Nature of Project:
Construct new residence

APPLICATION FOR A CERTIFICATE OF APPROPRIATENESS – STAFF REPORT

COA-0016-2019 405 E FRANKLIN STREET

Amendments: **Changes were made with the April 3, 2019 addendum; Reduction of the porte cochere width, a modification under the front accent roof, the retention of the existing walkway, and converting a double-width driveway to a single-width concrete driveway paired with concrete driving strip and a gravel median. Additional evidence presented at the March 28 meeting was also included with the amended application.**

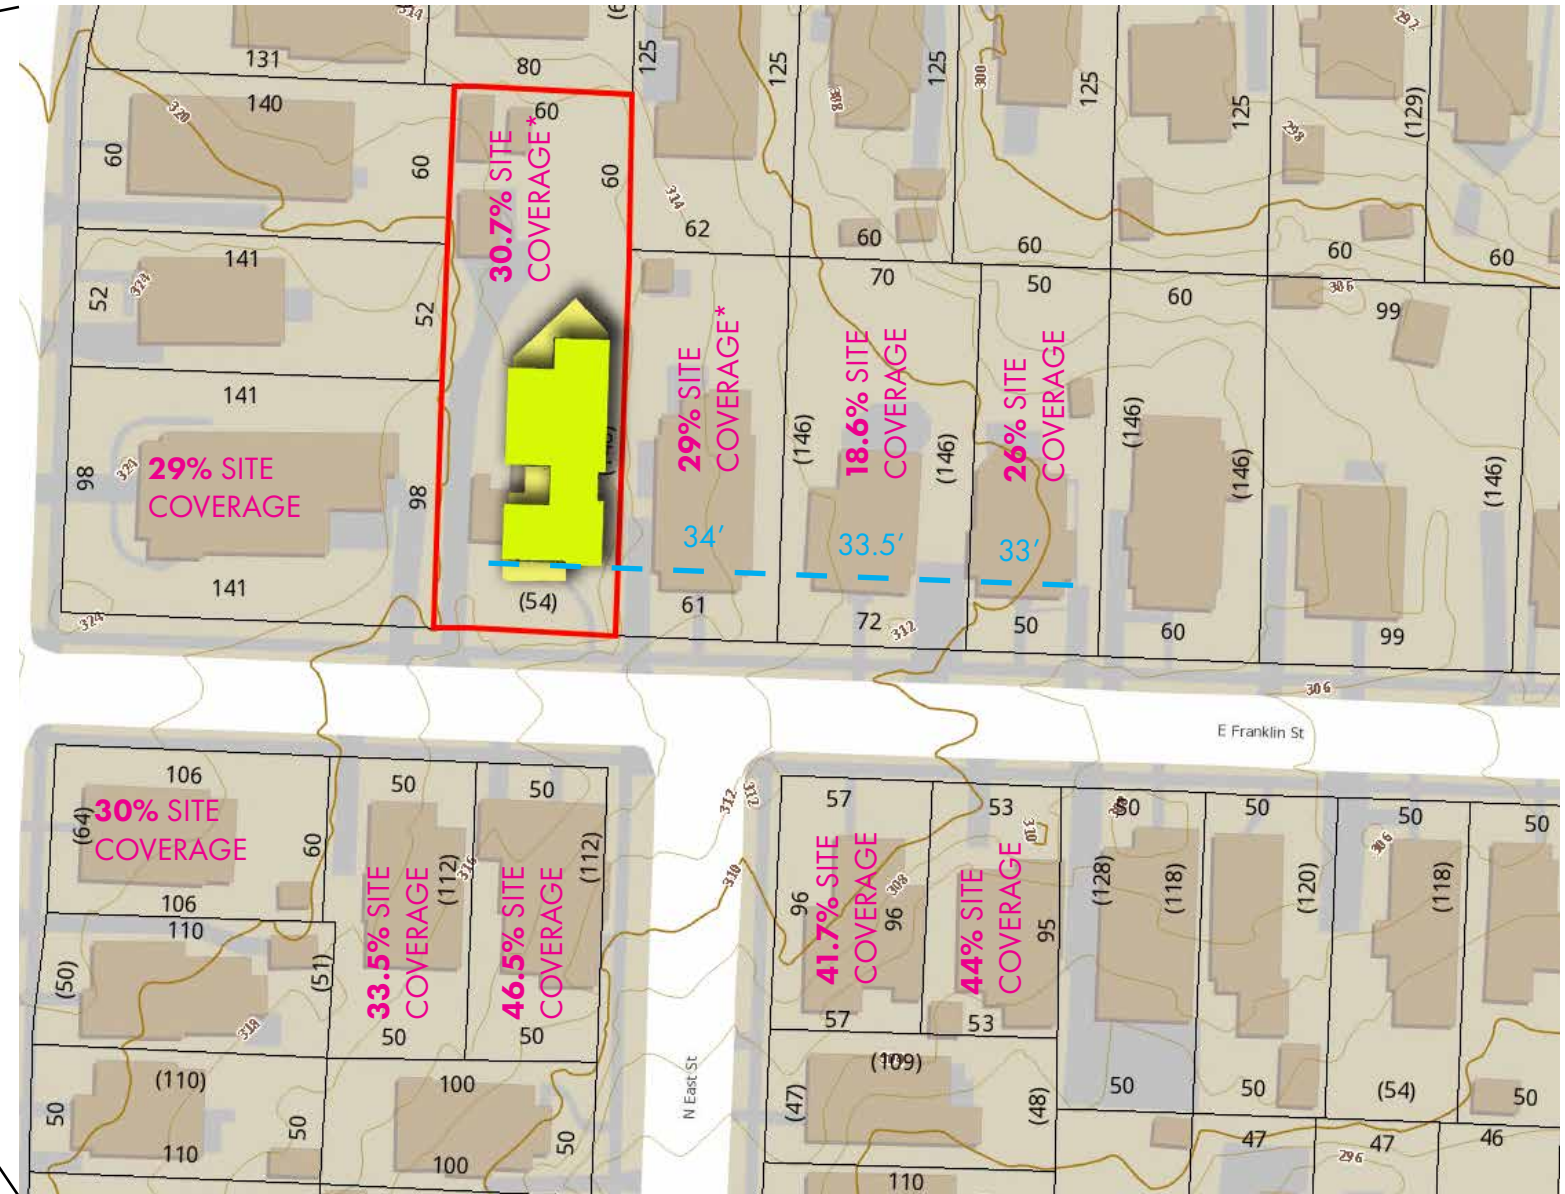
- 3* The proposed setback from the sidewalk is approximately 33.75'. The three properties to the east are shown with setbacks from 33' to 34'.
- 4* The new house is oriented to face Franklin Street and maintains a similar spacing between buildings as between those to the east. The siting of the house was governed in part by the location of large trees on the west property line.

- 6* The applicant states that the amount of built mass "does not vary significantly from nearby sites." A page in the application labeled "Neighborhood and Block Plan" (page 4) shows the footprint of the existing house alongside neighboring houses **including site coverages ranging from 18.6% to 46.5%.**

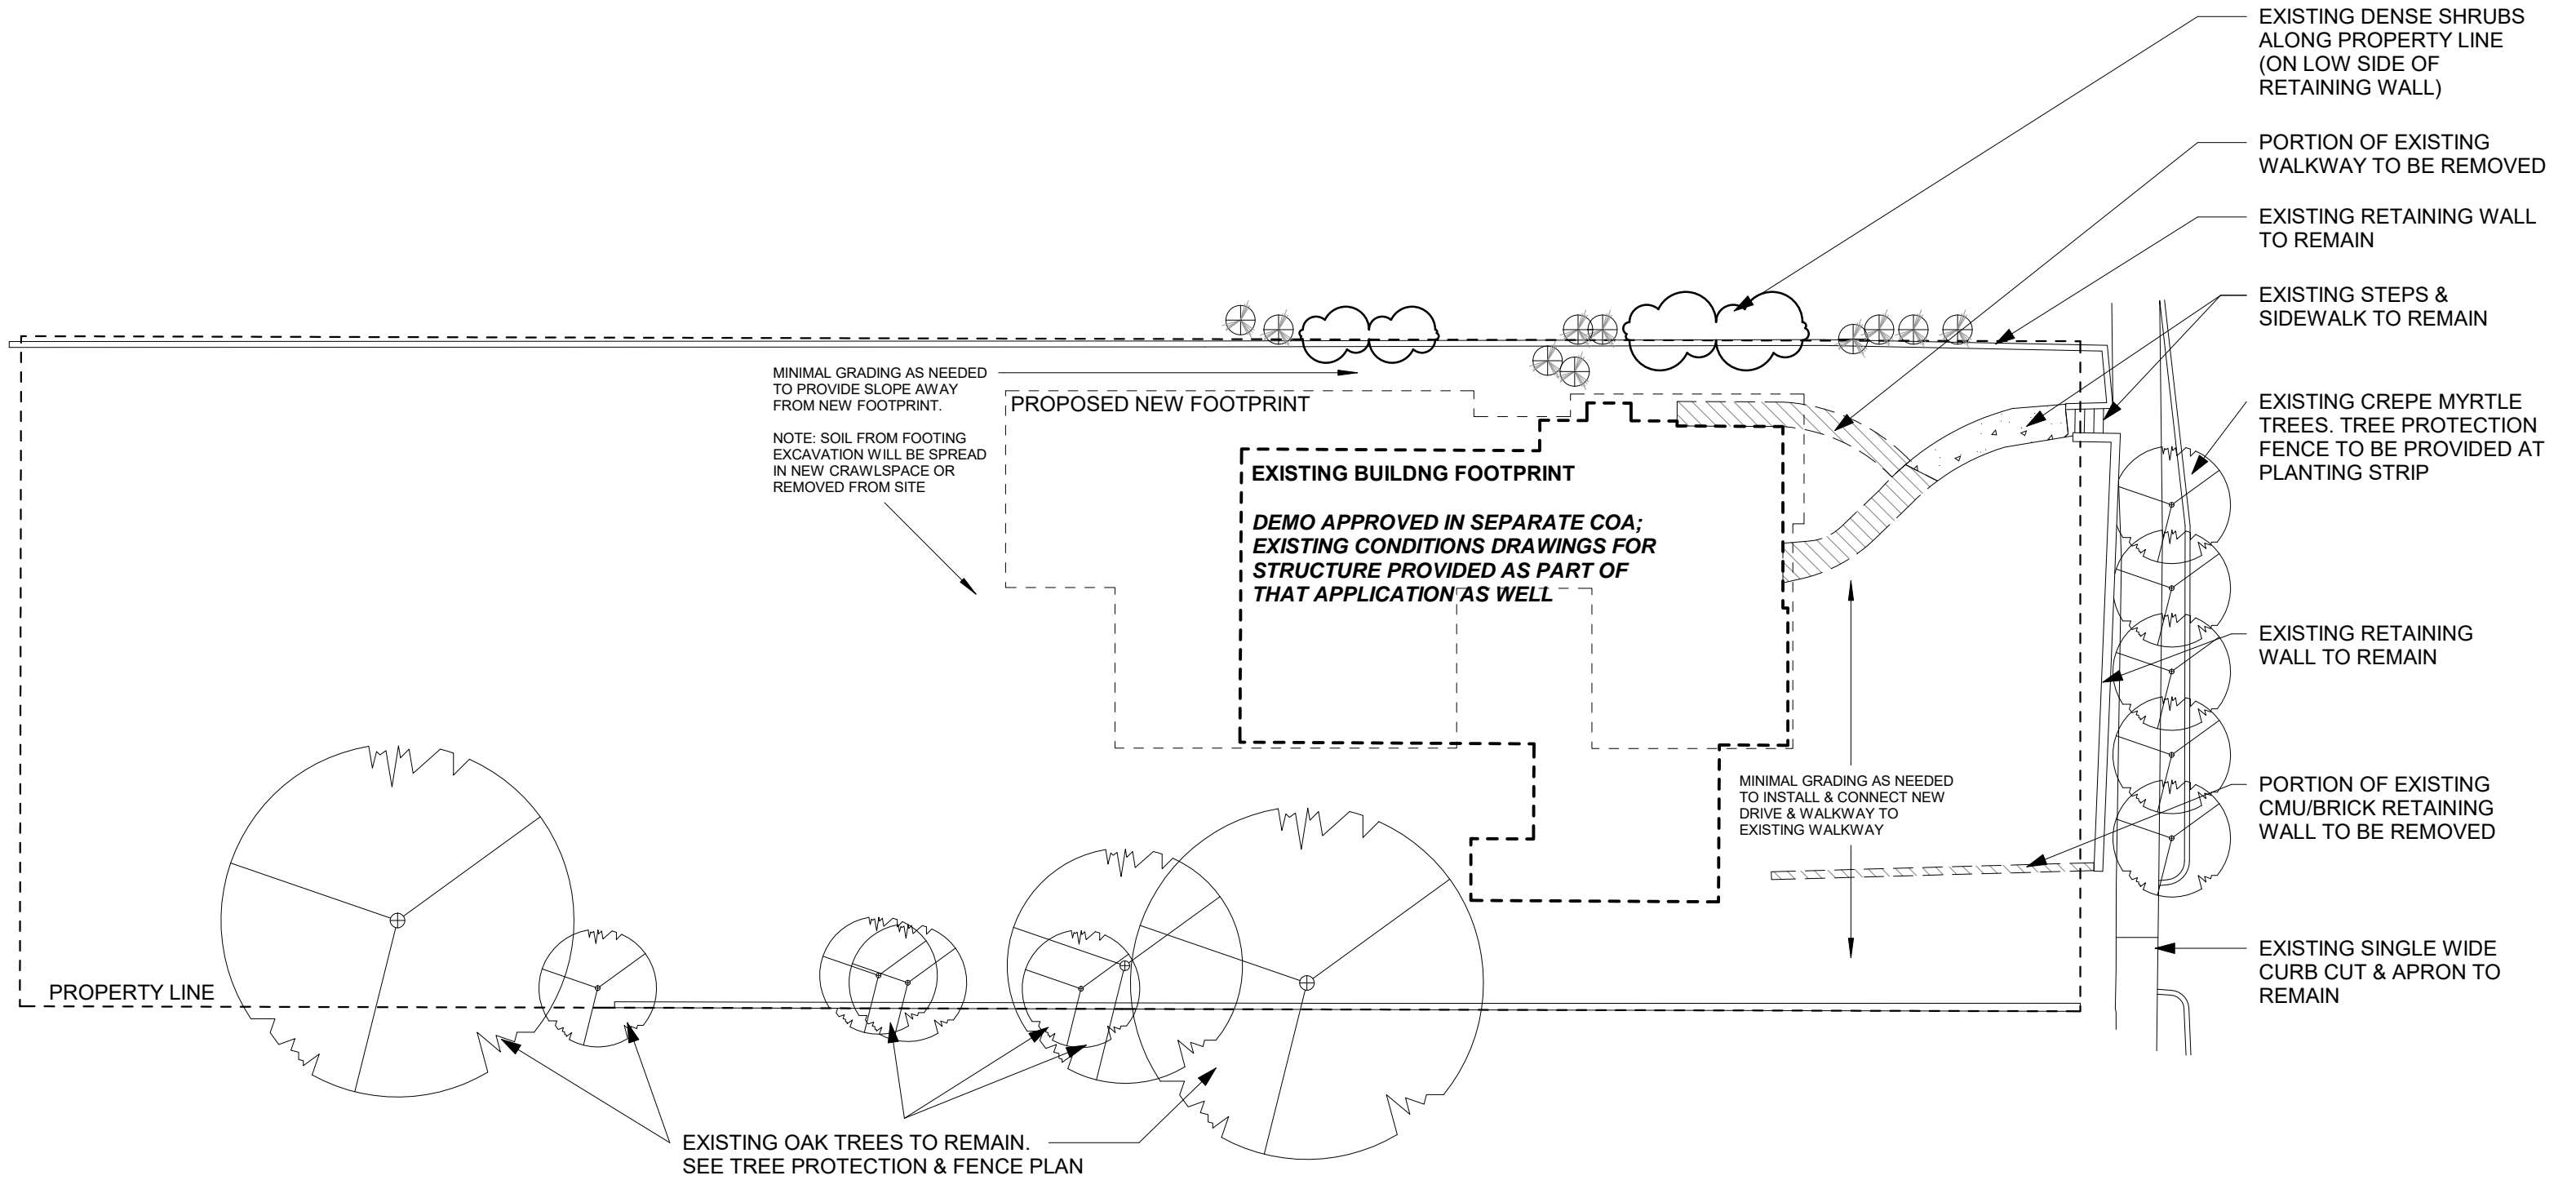
- 13* **Diagrams illustrating the height of four houses that flank the proposed design were provided; porch roof heights range from 10’ to 17’ for the neighboring houses while the proposed house includes a 12’ porch roof. Roof ridges range from 19’ to 33’-6” for neighboring houses while the proposed house includes a 28’-6” roof ridge.**

FRONT ELEVATION

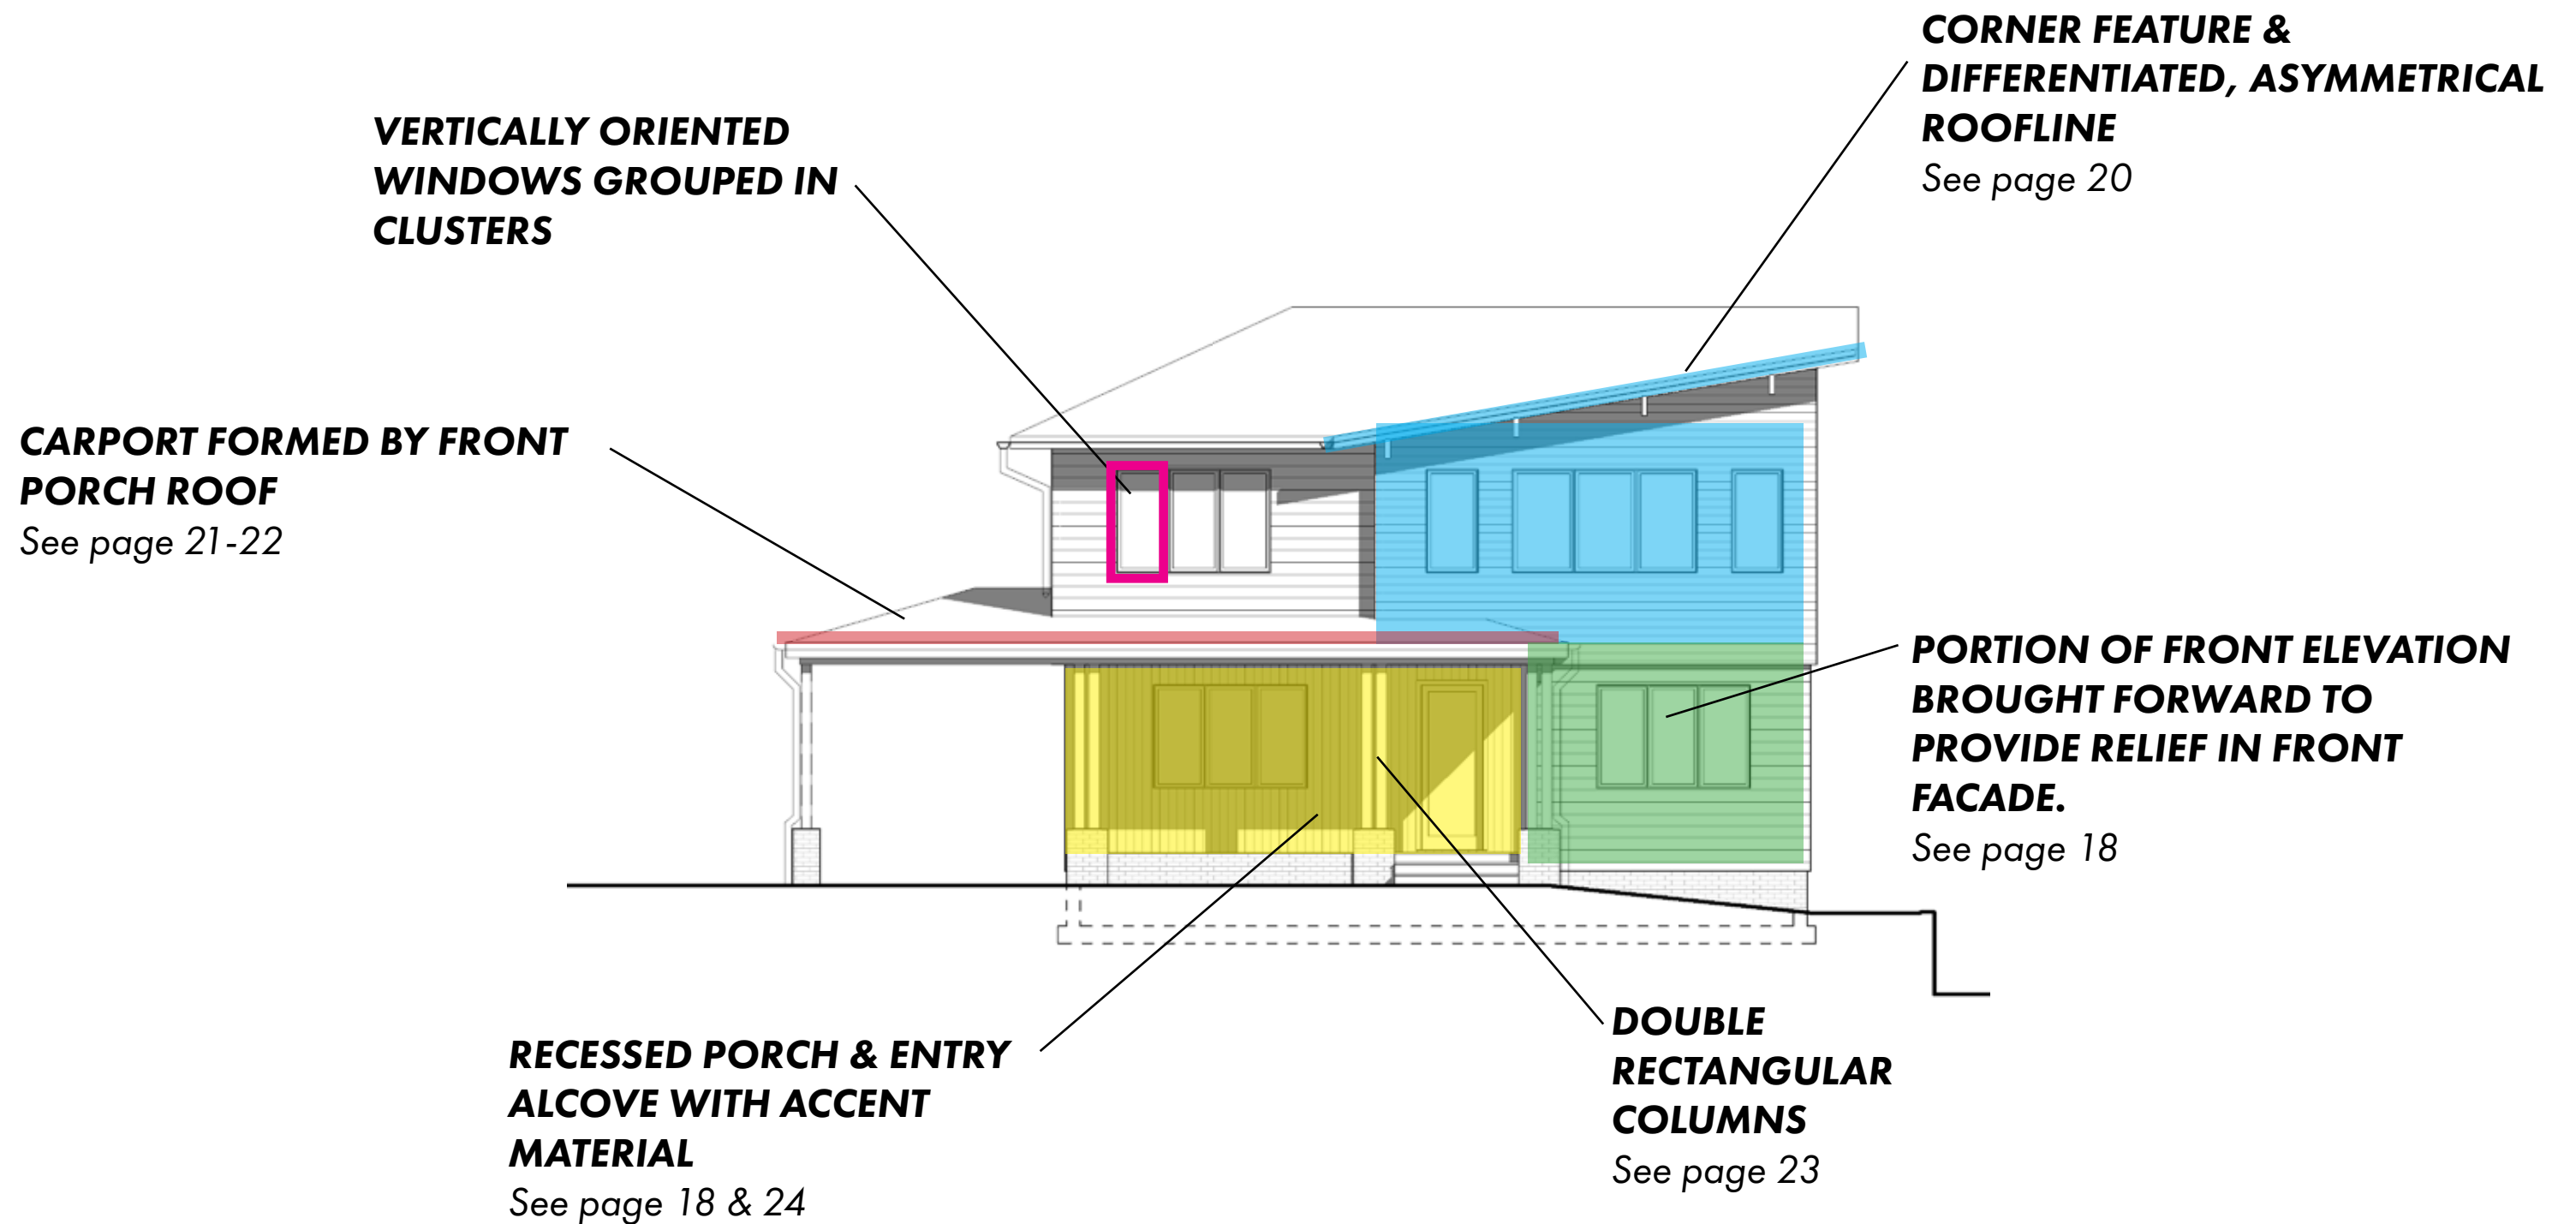
- 14* Three roof forms are found on the proposed design, all commonly found in Oakwood; hipped, shed, and gable. The roof over the 2-story portion combines all three forms with a shed form inserted into the main gable roof over the right front elevation (called a modified dormer in the application). The shed portion is atypical of the district; the high point of the shed roof is at the outer edge, with the lowest point near the middle of the front elevation.

- 15* **The southeast corner of the second floor slightly overhangs the lower walls as a compliment to the shed roof on the front of the house. This is best observed on page 19 of the amended application.**

- 16* The front shed portion of the roof is supported by exposed rafter tails (called roof support girders in the application); this is the only place where this element occurs on the house. Specifications were not provided for the exposed rafter tails.
